Recall – SureLock II Weight Pocket Handles
** Aqua Lung Consumer Notice **

Recall – SureLock II Weight Pocket Handles

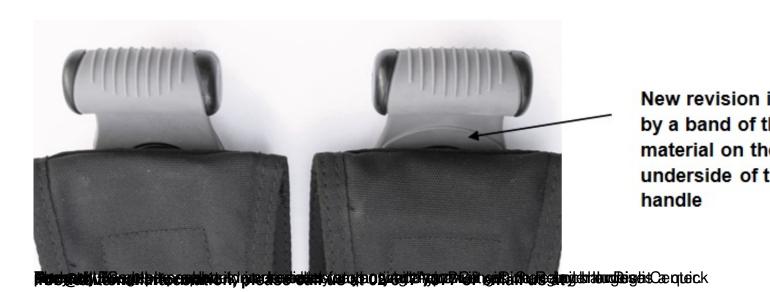
Aqua Lung is conducting a voluntary recall of SureLock II weight pocket handles. Sure Lock II is the mechanical weight release system found on most Aqua Lung buoyancy compensators (BCs) beginning in 2009. Aqua Lung is concerned about the rubber handle pulling off of the plastic Sure Lock II weight pocket assembly. If this were to occur during a dive, the weight pocket would be left engaged inside the BC. There are no known occurrences of this happening underwater, and there have not been any reported injuries, but Aqua Lung believes that a recall is the safe and prudent thing to do.

Aqua Lung has made a revision to the handle assembly that strengthens it. A revised handle is easily recognized by a thickened band of rubber at the base of the handle.
